Planning Commission Staff Report

Consideration of a Preliminary Plat for the Antonio Plat “A” subdivision consisting of three lots located in the RA-2 zone.

MAPLETON CITY DEVELOPMENT REVIEW COMMITTEE MINUTES

October 13, 2016

PRELIMINARY PLAT

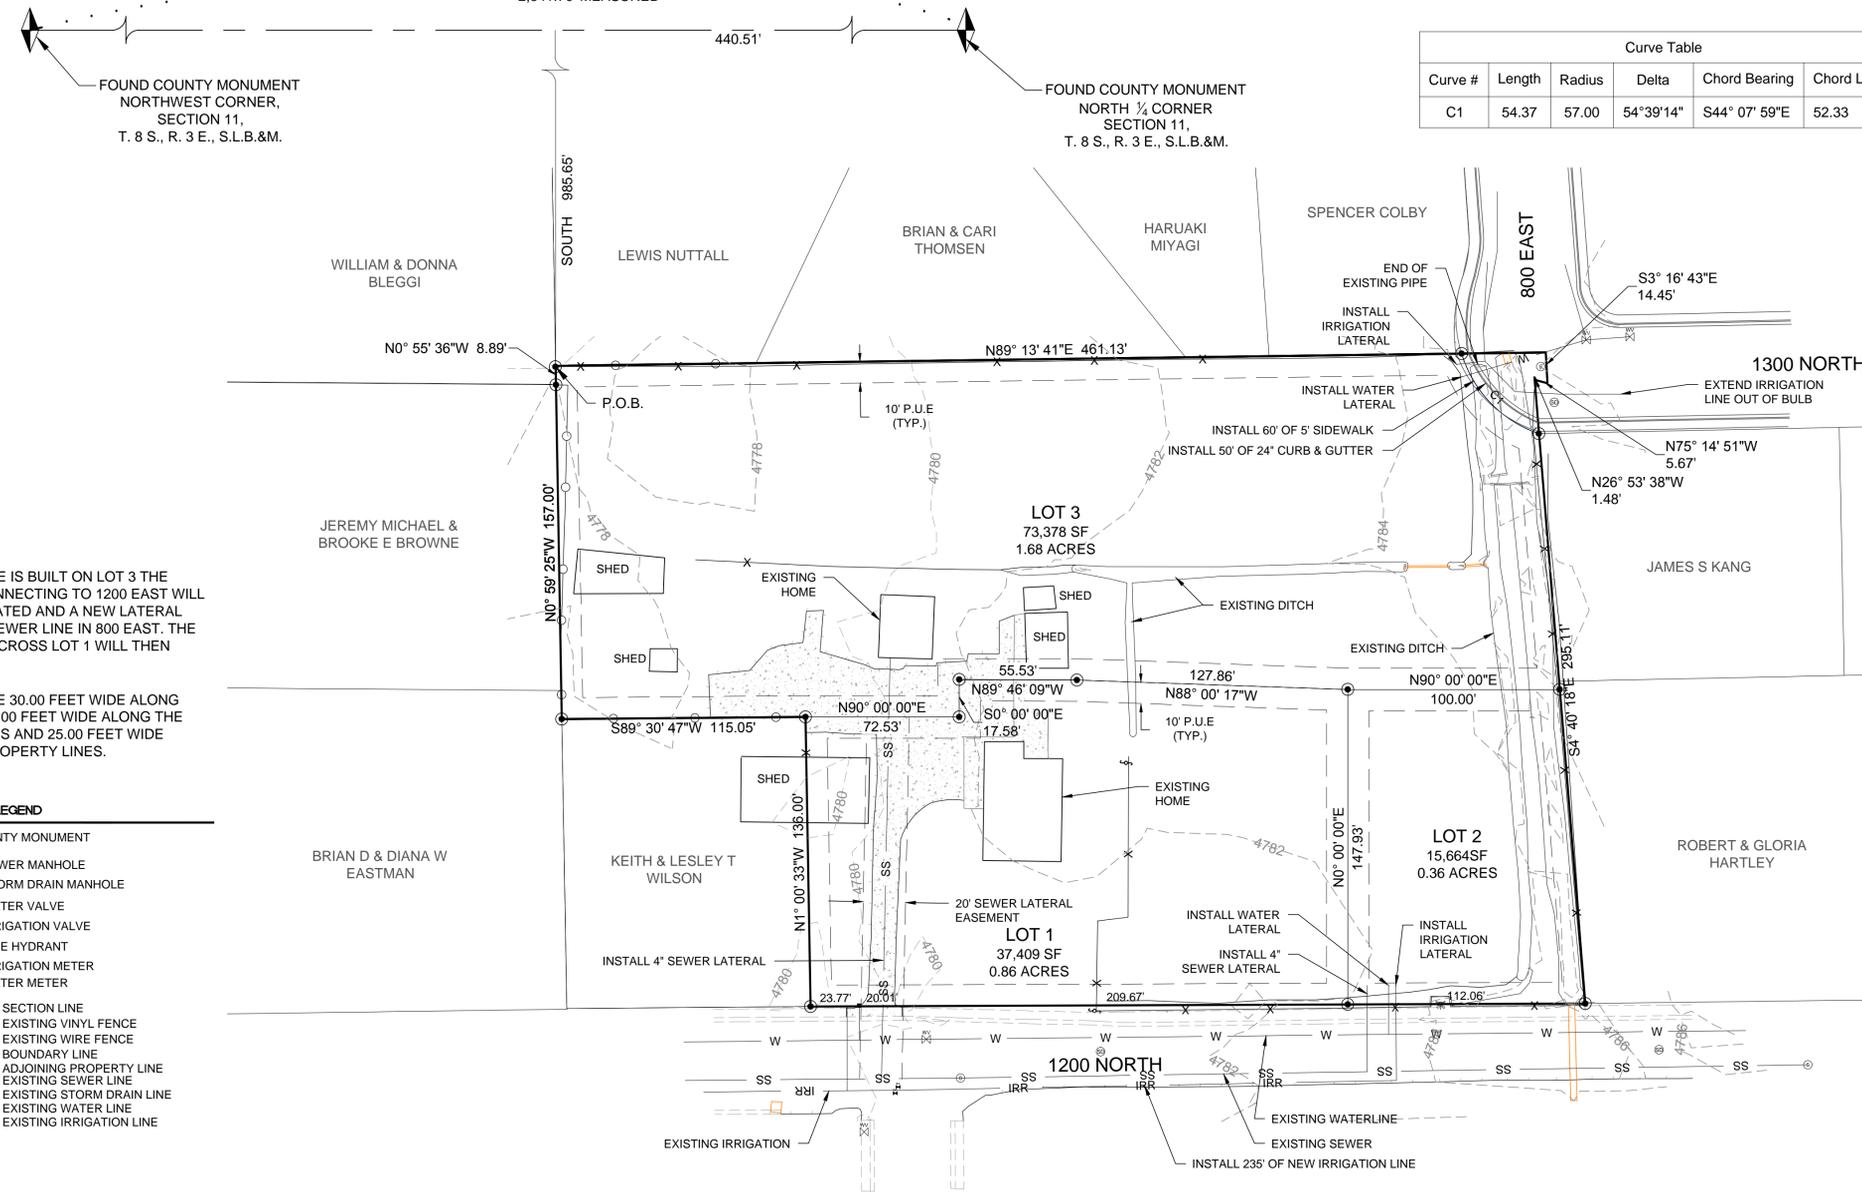
- The project will require approval of the Preliminary Plat by the Planning Commission and Final Plat by the DRC.
- Please show all ROW dedications with cross hatching on the plats.
- The dimension callouts on lots 1 & 2 do not appear to be correct.
- With the new property line being created for lot 3, there are several buildings on or near the new property line. All structures that are 15' tall or over shall be setback at least 10' from the property line. If the structures are less than 15' that must be setback a minimum of 3'.
- Please include the following addresses on the final plat
 - Lot 1: 745 E
 - Lot 2: 791 E
 - Lot 3: 795 E 1300 N
- Any boundary gaps and overlaps shall be corrected prior to plat recording.

1. If owner is going to build on Lot 3 fronting 800 east 1300 north in the future, sewer lateral should be placed in lot 3 frontage (it will be required to disconnect sewer lateral at main in 1200 north and lateral installed in frontage of lot 3 if build in the future—with lateral installed in 1200 n now).

1. Show on plans Detail for culinary water service.
2. If owner is going to build on Lot 3 fronting 800 east 1300 north in the future, water lateral should be placed in lot 3 frontage (it will be required to disconnect water lateral at main in 1200 north and lateral installed in frontage of lot 3 if build in the future—with lateral installed in 1200 n now).

1. Show PI lateral for Lot 3.
2. Show on plans including profile, extending new 8" PVC C900/905 SDR 18-Main across frontage of lot 1 & 2 with PI lateral for lot 2 on 1200 north.
3. Extend 8" PI Main across 800 east and into 1300 north (out of knuckle).
4. Show on plans Detail for PI Single Service Lateral.
5. Show Secondary Irrigation Service Meter Detail Pressurized Irrigation – 02.

1. Asphalt thickness to be 3" on 800 East and 4" on 1200 north.

1. All concrete shall be brought up to standard (broken or cracked sidewalk & curb & gutter).
2. Receive irrigation company approval for work on Mapleton Irrigation Company ditches.
3. Show on plans Details for pedestrian ramps.
4. Show Plan and Profile views with horizontal and vertical scaling.
5. Current Mapleton Addendum to APWA and APWA standards will apply.
